CITY OF ST. PETERSBURG, FLORIDA  
PLANNING AND DEVELOPMENT SERVICES DEPARTMENT  
URBAN PLANNING AND HISTORIC PRESERVATION DIVISION

### Community Planning and Preservation Commission Certificate of Appropriateness Request

**CITY FILE NO.: 20-90200007**

Approval of a Certificate of Appropriateness for alterations to a contributing resource to the Kenwood Section – Northwest Kenwood Local Historic District (18-90300008)

**Figure 1: 1951 Sanborn Map, Sheet 347, St. Petersburg, Florida, with subject property outlined**

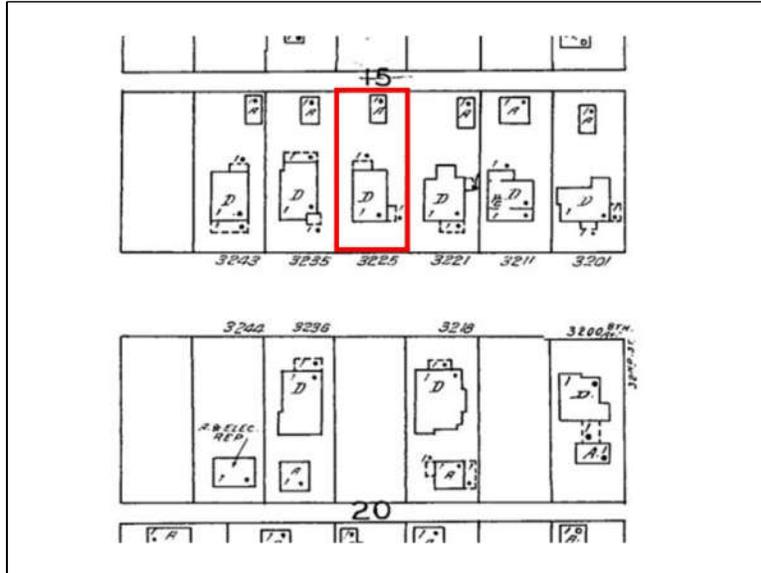
The 1932 garage building was demolished at an unknown date, likely prior to 1968, as a permit was issued that year for the construction of a carport. The current proposal includes demolition of this carport, as well as the construction of a new accessory building with general similarities of size, design, and orientation/location on the parcel to historic garage buildings visible in Figure 1.

The 1932 garage is visible in the 1951 Sanborn map (Figure 1) of the area. Its demolition date is unknown.

**Figure 2: Alley-facing (north) elevation, from application**

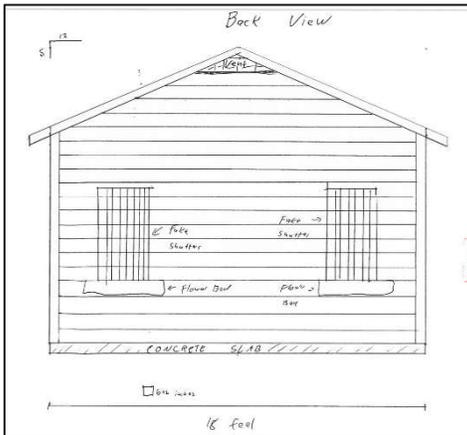
The new building will not feature alley-facing garage doors as is most typical of accessory buildings in the district. Rather, the alley-facing (north) elevation will feature two false windows and flower boxes (Figure 2). This will be the sole elevation that is located outside of the property's fence line, and, therefore, directly visible from elsewhere in the district. It is, however, important to note that this exposed elevation will face the alley, which is dominated by buildings of utilitarian, albeit often historically significant, design (Figure 3).

However, the alley-facing elevation will feature false windows rather than garage doors.

**Consistent** Proposed windows at the south (interior-facing) elevation are 24 3/8" wide by 36 1/4" high. Exact dimensions of the false windows at the north (alley-facing) elevation are not specified. In each case, the windows' (or alluded windows') size is vertical in orientation, which is in keeping with predominant design principles of pre-war resources in the subject district.

**Figure 4: Proposed south elevation (to face rear elevation of primary residence on property), from application**

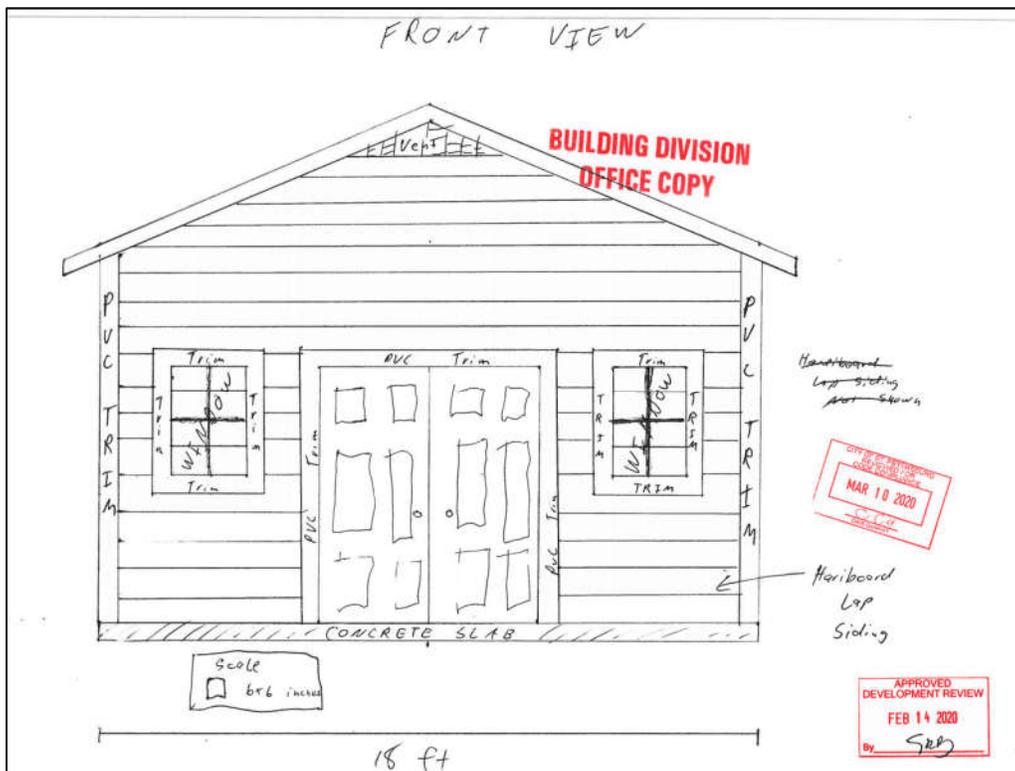
The building's entrance will face the interior of the subject property, with dual-action paneled doors flanked by two windows at the south elevation (Figure 4).

**Consistent** Windows and doors at the south elevation are evenly spaced and traditionally proportioned. Side elevations feature no fenestration, which is not entirely uncommon for utilitarian accessory buildings. The false windows at the north elevation are evenly-spaced.

1. Replacement windows will feature contoured, three-dimensional external muntins.
2. Windows will be installed to be setback within the wall plane and feature a reveal of at least two inches.
3. Trim will be constructed of Hardie board or wood, rather than proposed PVC.
4. Rear setback to be increased to 7' per code for the subject property's NT-2 zoning.
5. All other necessary permits shall be obtained. Any additional work shall be presented to staff for determination of the necessity of additional COA approval.
6. This approval will be valid for 24 months beginning on the date of revocation of the local Emergency Declaration.

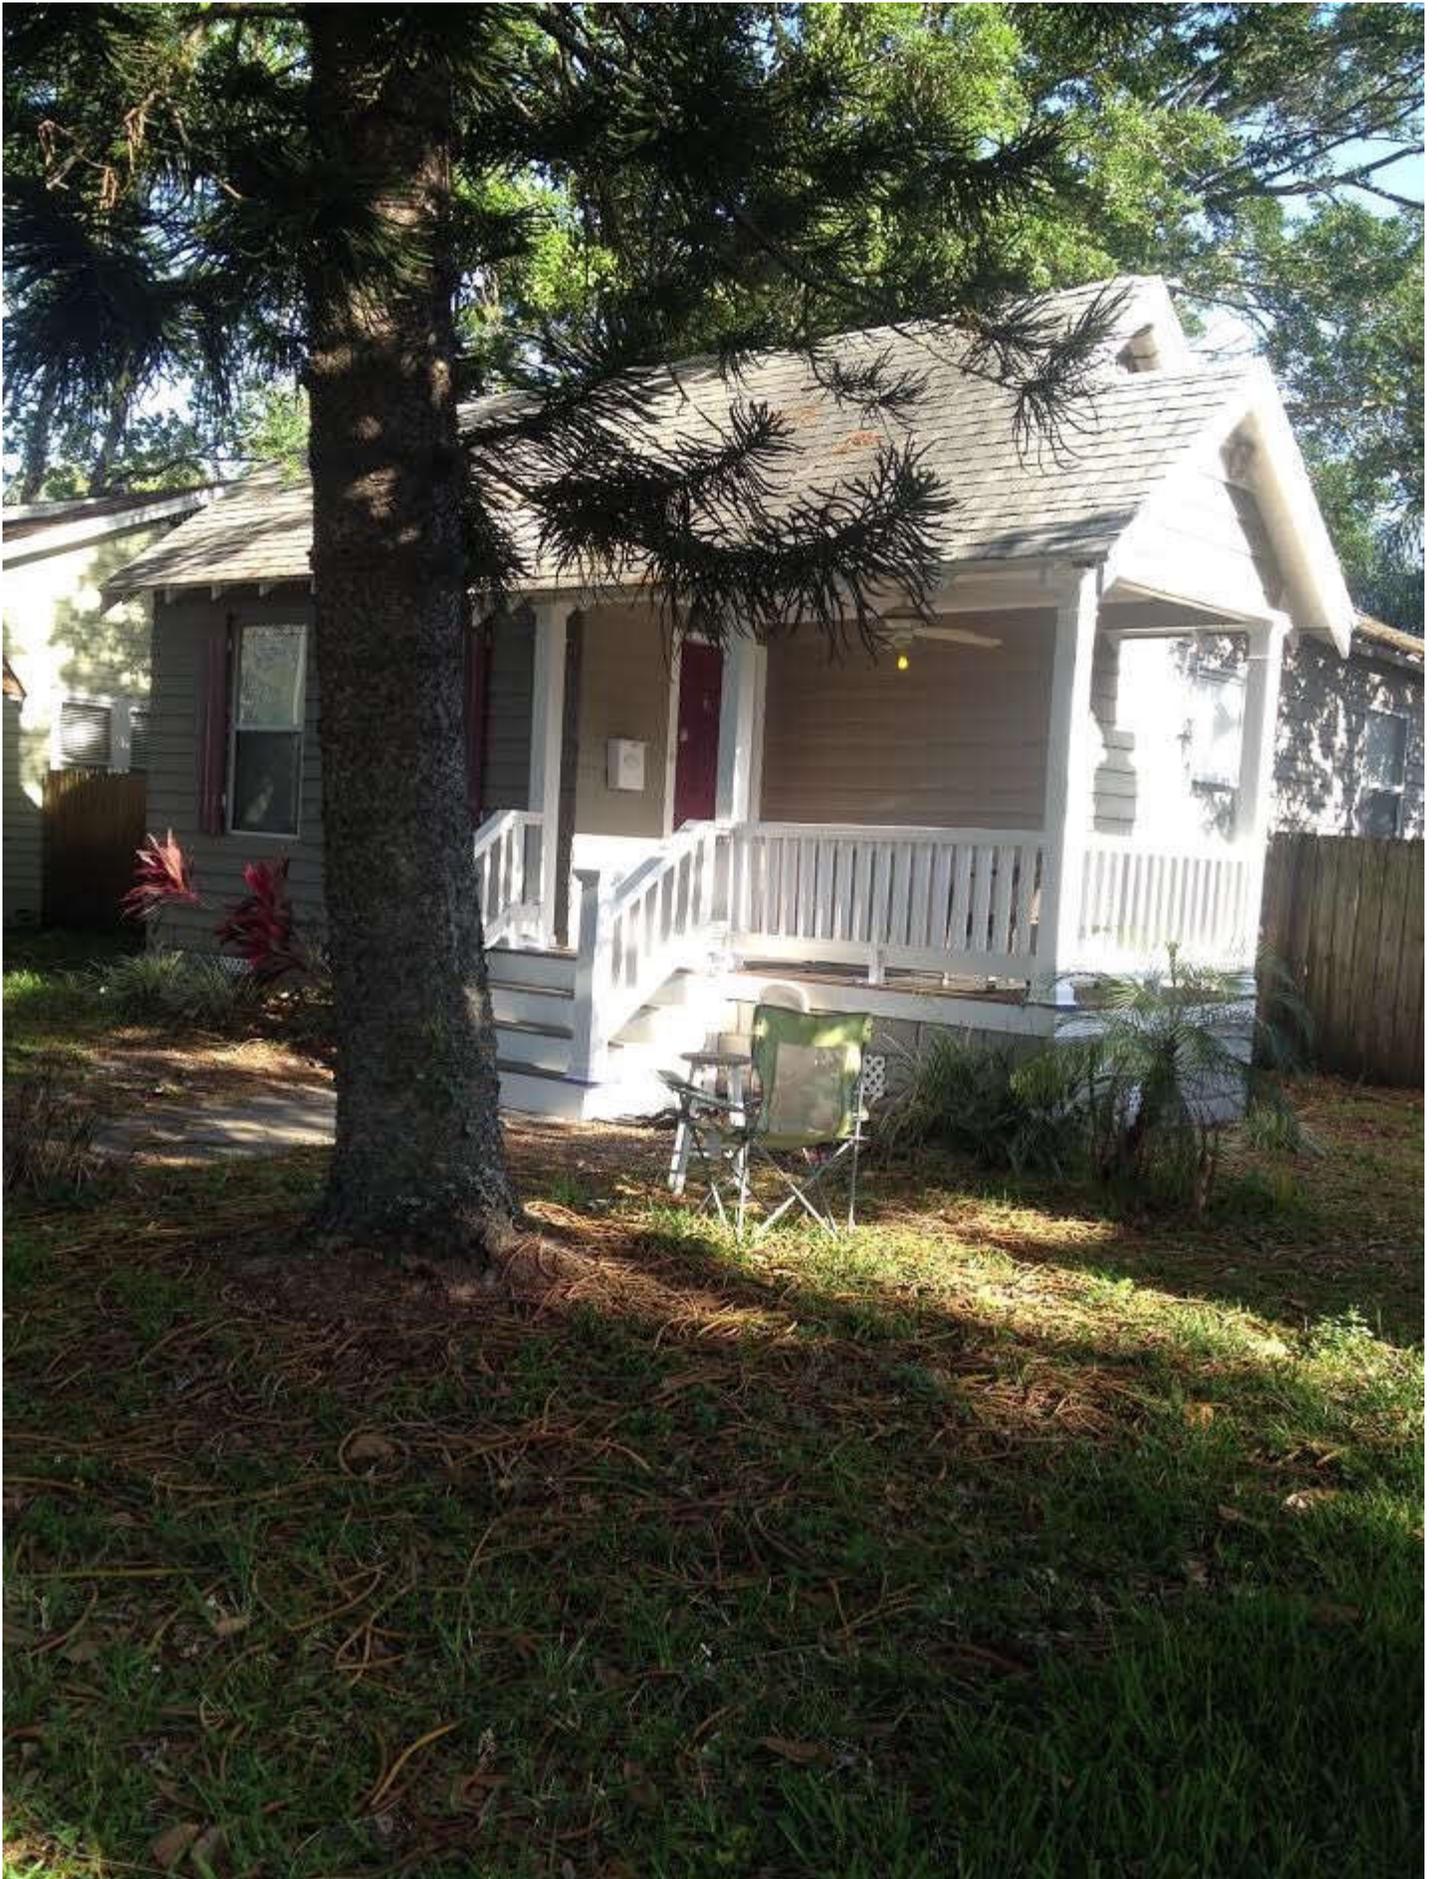
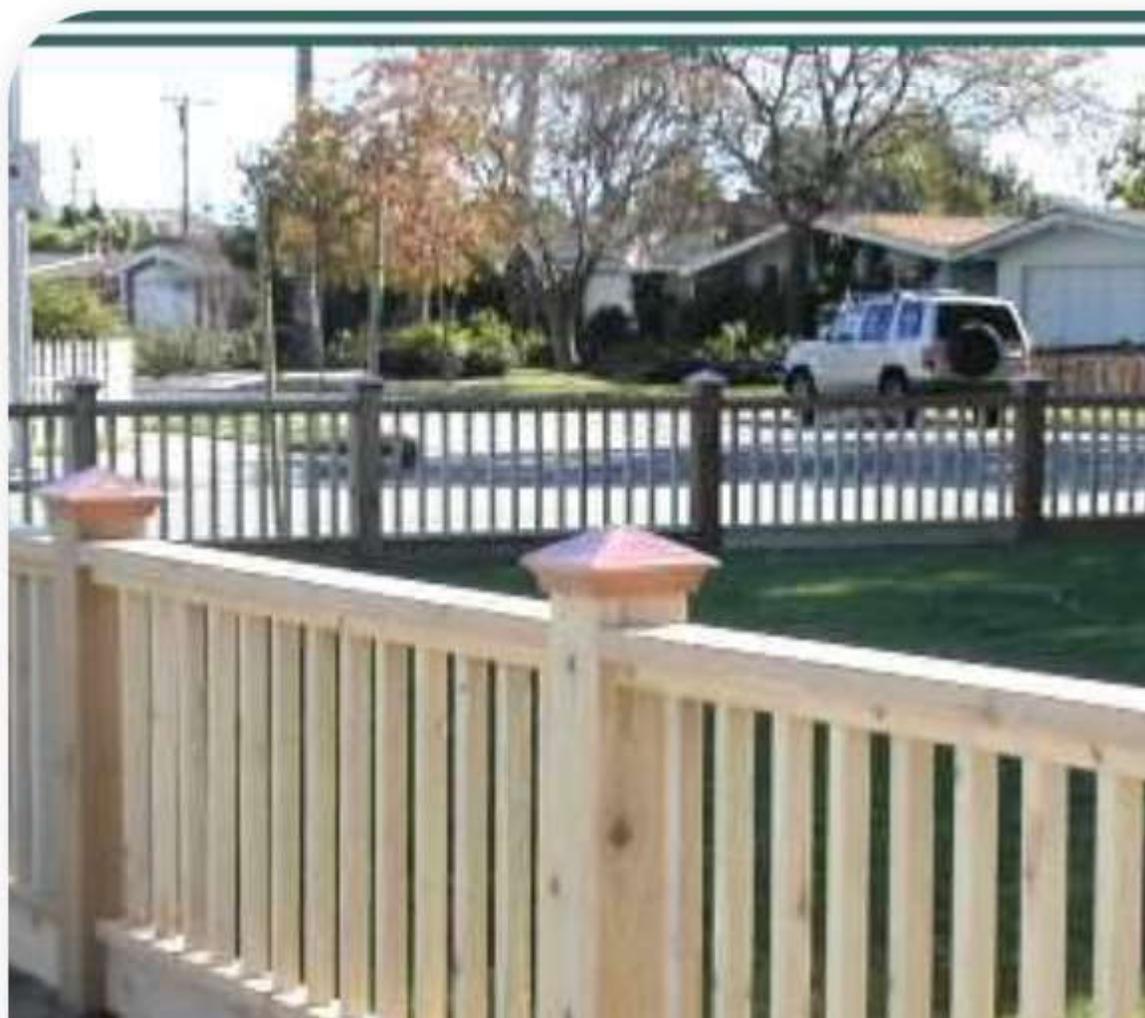
**Front Yard Fence: Inconsistent**

Front fences are less common than open front lawns within the subject district and larger Kenwood neighborhood. In a planned 1920s streetcar suburb with relatively generous parcel sizes for the period such as Kenwood, this openness throughout the front setback was likely prevalent during the period of significance.

However, the proposed fence is fairly low at three feet, replicates the design of existing porch railing, and is a reversible element that will not affect the historic building.

Is this design in compliance?

I was planning on building it out of wood and having it three feet tall. The plan is to have it match my porch railings (photo of my front porch attached. The posts will be 6x6 and the French made of 2x4 and a top 2x6. The posts spanning eight feet with a 5.5 matching gate at the front. On the sides of the property it will be on the property line and will end a foot prior to the sidewalk. I am also attaching a photo of what the proposed French will look like as well. The fence will be attached to the posts using L brackets and the entire fence will be painted white.
